Memorandum

Subject: Variance request for an existing septic system, SNHD Permit #ON0010273, located

at 2625 Barbaradale Cir., Las Vegas, NV 89146 to allow existing trees to encroach

on the septic system

Attachment D: Tenant Improvement Review by SNHD Staff (SR0056341) (Page 1 of 4)

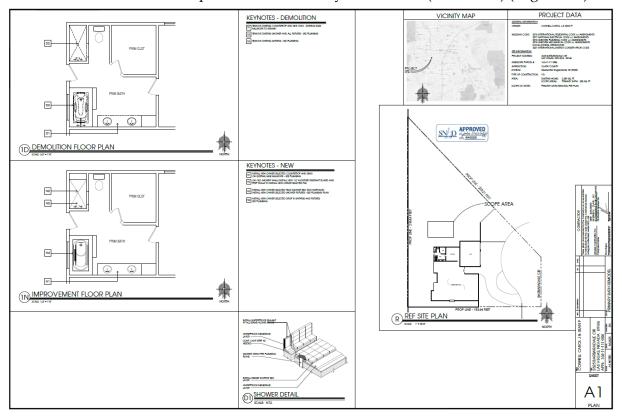
There are a few trees on and within 10ft of the leach field and septic tank. As stated in Section 11.3 of the Individual Sewage Disposal Systems and Liquid Waste Management Regulations, these trees will need to be removed and send photographic evidence to SNHD for final approval.

The permit for the updated plumbing fixtures can be released but PLACE A HOLD ON THE FINAL INSPECTION.

Attachment E: Final Inspection Report and Plot Plan for ON0010273 (Page 2 of 3)

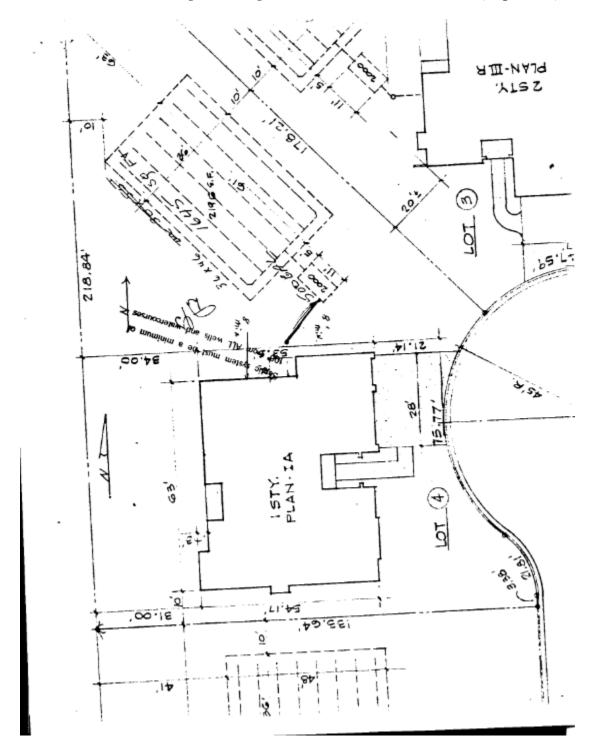
The existing trees located on and near the head of the leach field pose a risk to the septic system via root intrusion. Root intrusion can cause hydraulic failure, which may result in sewage backup into the structures being serviced by the septic system or surfacing of sewage over the leach field; however, the presence of trees allows for uptake of the effluent by the roots, which may improve treatment of the effluent.

Staff are of the opinion that granting the variance would not endanger public health or safety; however, staff recommend DENIAL of the variance due to the Subject Property's use of Colorado River Water, the location of the trees directly above and near the head of the leach field, and the system's age. If the Board of Health approves the variance, staff recommend approval with the following conditions outlined in Section III.
